Product Change Notification Number: 200301**Date:** 16.01.2020**Title:** Change of label**Product Identification:** ASx14x00

ASP1400 (1-100012-02), ASP1400-20 (1-100013-02), ASP1400-100 (1-100014-02)

ASF1400 (1-100011-02), ASF1430 (1-100042-01)

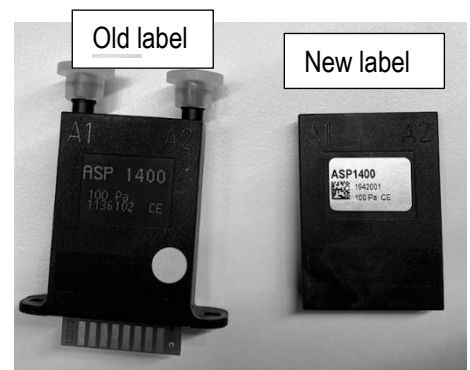
Old: label information directly printed on housing

New: label information printed on label sticker (with same information + Additional data matrix code)

Reason: Due end of life of the printer used to print directly on the product (plastic housing). Replacement of the old printer would be to expensive therefore using a label sticker is a cost efficient alternative.
